PLANNING AND ZONING CASE CHECKLIST

P&Z CASE # SP2020-001 P&Z DATE 01/28/2020 CC DATE 02/18/20 APPROVED/DENIED
ARCHITECTURAL REVIEW BOARD DATE _____ HPAB DATE _____ PARK BOARD DATE _____

Project Number: SP2020-001
Project Name: 726 I-30 Frontage Road
Project Type: SITE PLAN
Applicant Name: MICHAEL LEGG
Owner Name: MATHEW PARMERLEE
Project Description:

ARCHITECTURAL SITE PLAN
GOLDEN CHICK RESTAURANT
726 I-30 FRONTAGE ROAD
ROCKWALL TEXAS

1 ARCHITECTURAL SITE PLAN
A1.0 SCALE: NTS

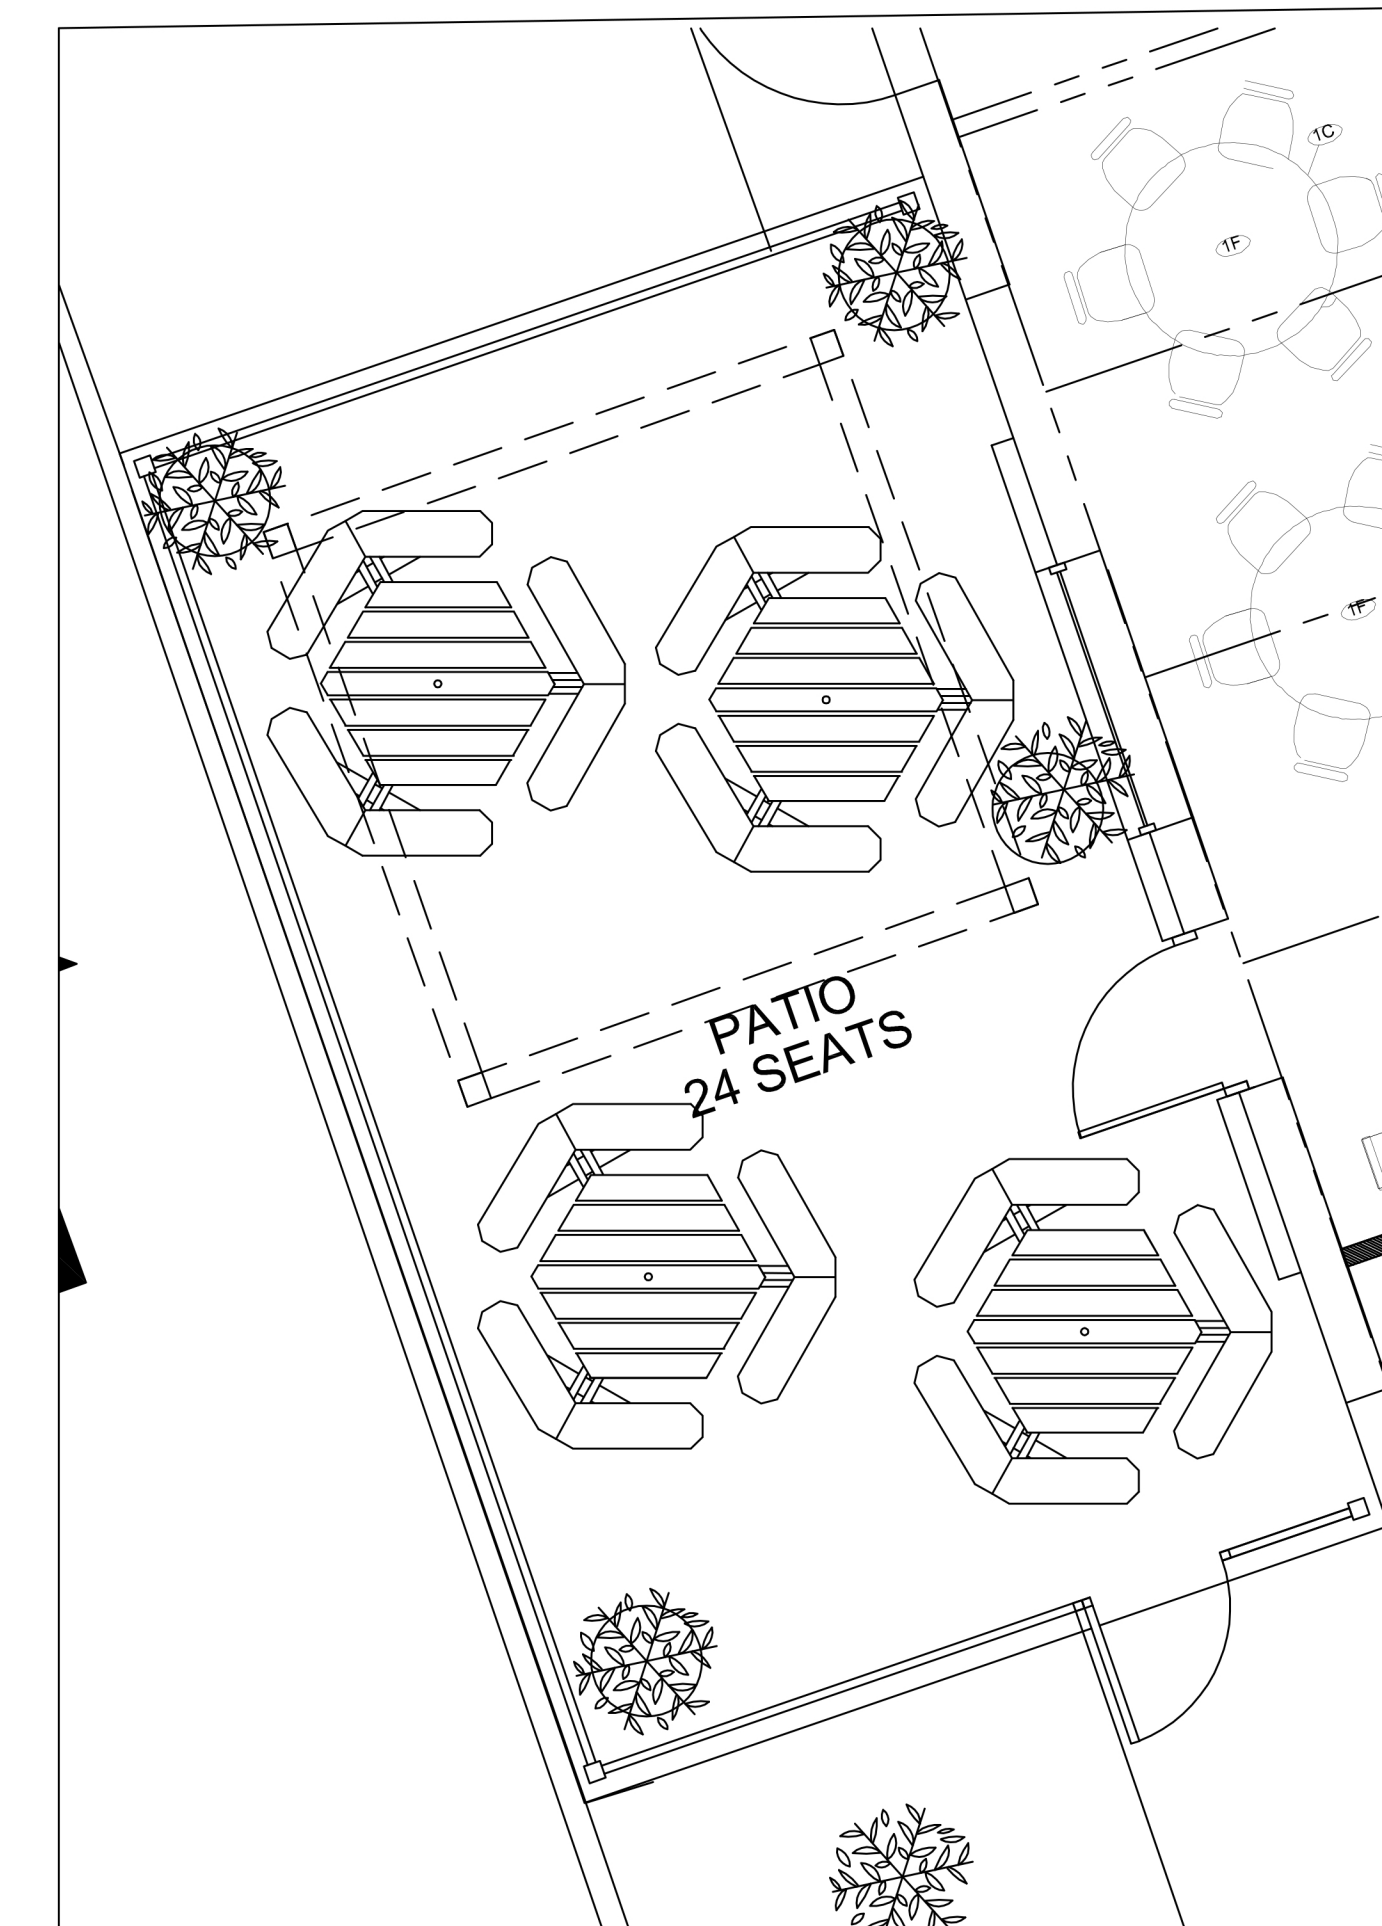
4) Please show and label front setback.
						5) Please dimension a typical parking space.
						6) Please show centerline of IH-30 Frontage Road.
						7) Please note, canopy trees are a min. of 4 caliper inches, accent trees are a min. of 4-feet in height, and shrubs are a min. of 3 gallons.

11) Please provide site data table as requested above for site plan
						12) Please adjust orientation of the "Plant List" label and the plant list table. Currently, they overlap.

SHEET NO.
A4.0

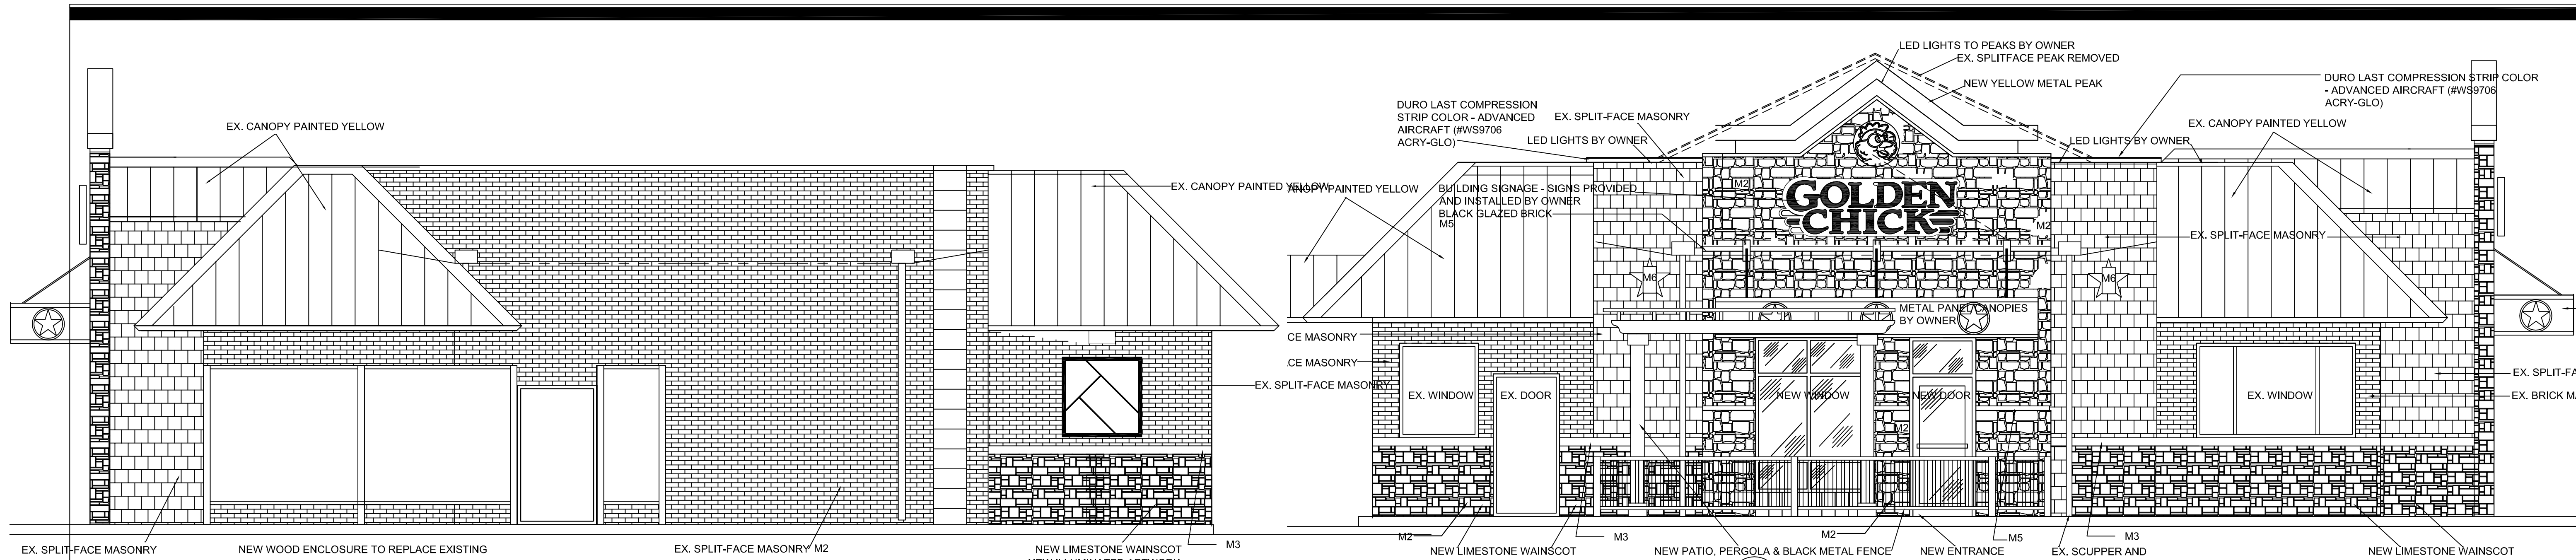
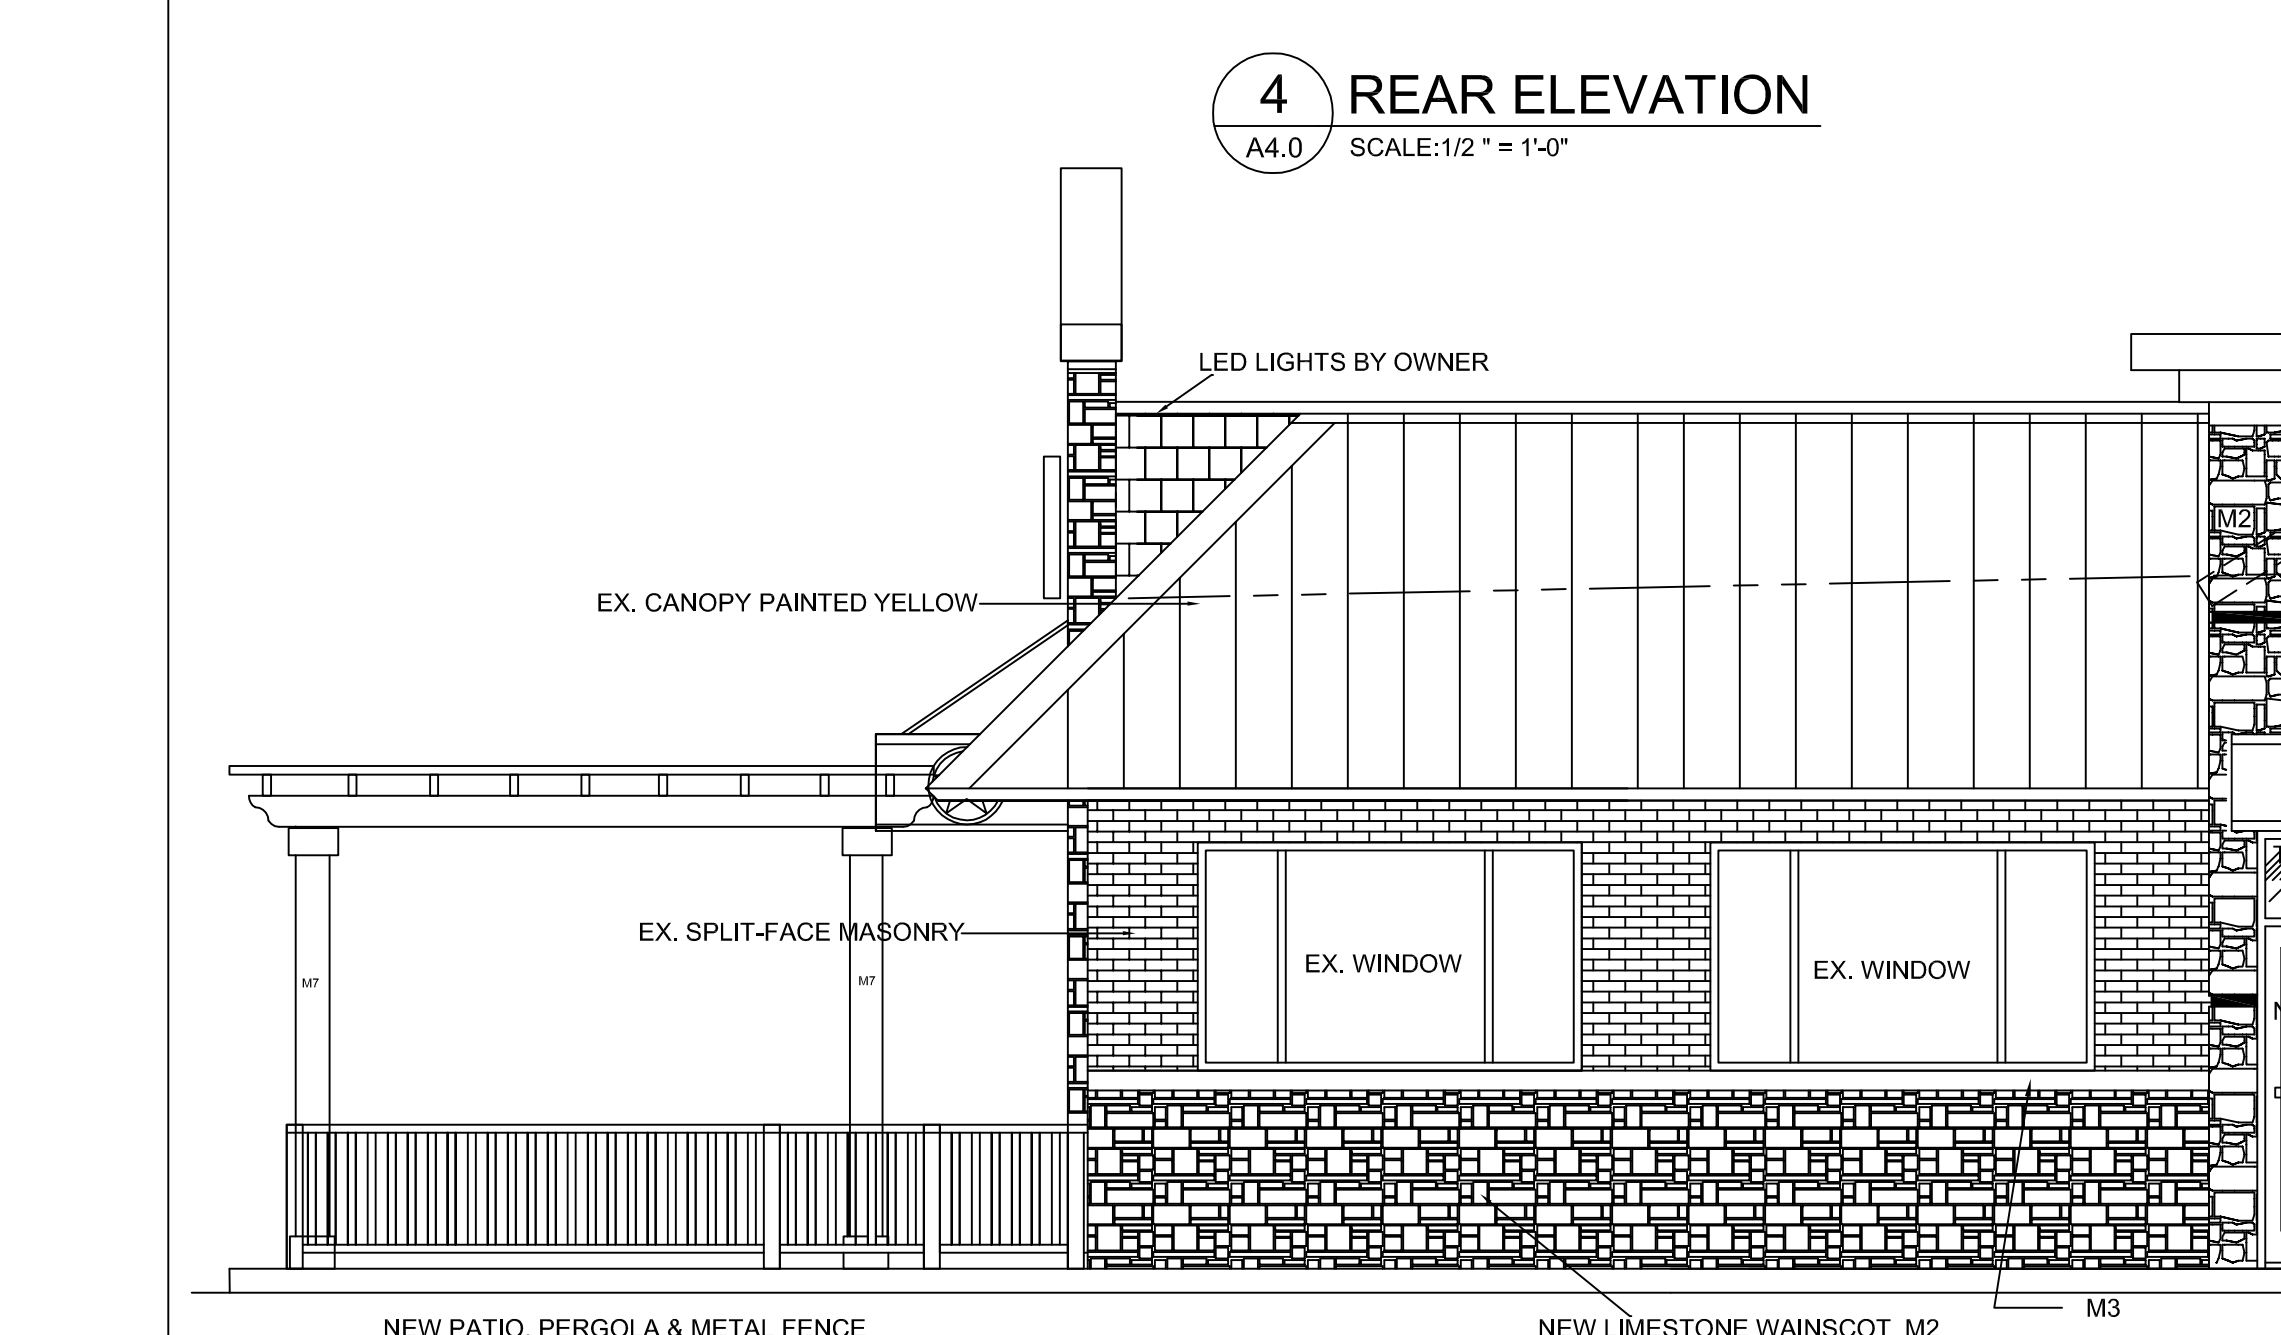
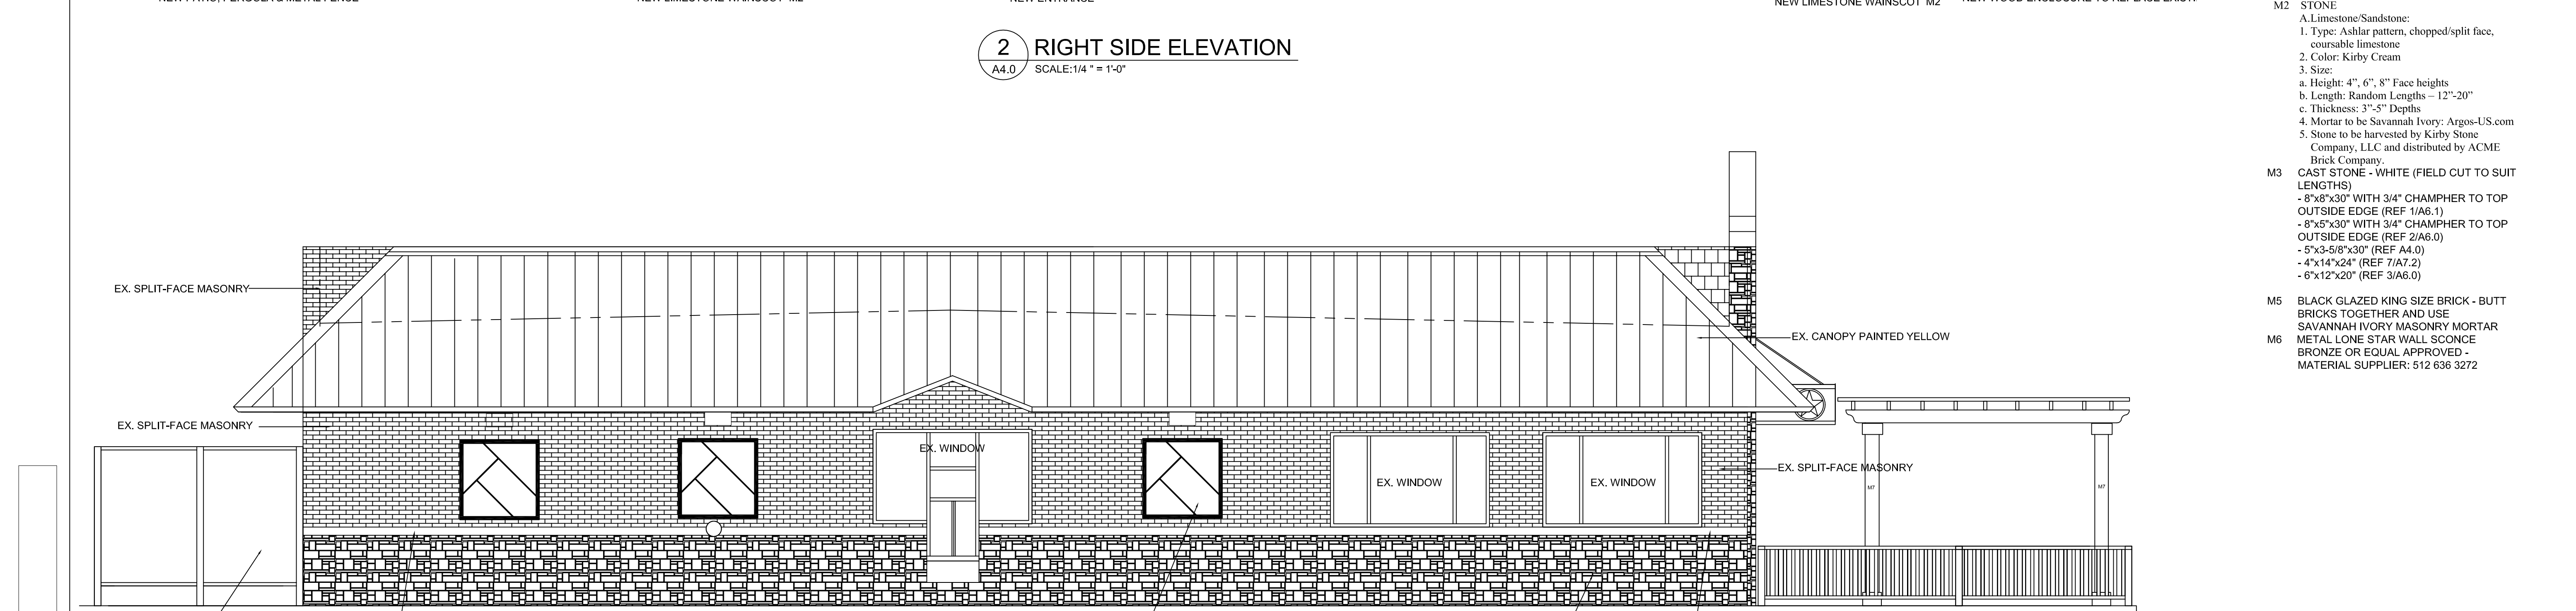
1) Please remove all signage from building elevations. Signage is approved at time of building permit.
						2) What material will the illuminated artwork be?

3) Please provide cardinal direction of building elevations and indicate which elevation faces the street
						4) Please note, the two tower elements (where the signage is located) will need to be finished on the sides and the rear. The tower element will need to appear as a "cube" rather than a "flat panel" that projects from the top of the building.

7) Please note that on the Rear and Front elevations, there is a label for "Ex. Split-Face Masonry" –located between the two elevations. This appears to point to brick instead of split-face. Please confirm material. Also, there are two labels for "CE Masonry". Please clarify.

8) Please provide site data table as requested for the site plan
						9) Please provide dimensions/heights
						10) Please clarify rear elevation. There appears to be a ladder on the building, please label.

11) Please note that above the artwork on the rear elevation, there seems to be an missing building materials.
						12) Please label windows and doors on rear elevation.

13) Please label dashline on the roof
						14) Please provide dumpster enclosure elevations. Photometric Plan.
						1) Please provide photometric plan
						I.6 Please note that failure to address all comments provided by staff by 5:00 PM on February 4, 2020 will result in the automatic denial of the case on the grounds of an incomplete submittal. No refund will be given for cases that are denied due to an incomplete submittal and a new application and fee will be required to resubmit the case.
						I.7 The Architectural Review Board (ARB) meeting is January 28, 2020 at 5:00. Planning & Zoning Worksession is January 28, 2020 at 6:00.
						I.8 The Planning and Zoning Meeting for this case is February 11, 2020.
						A representative is required to attend all meetings
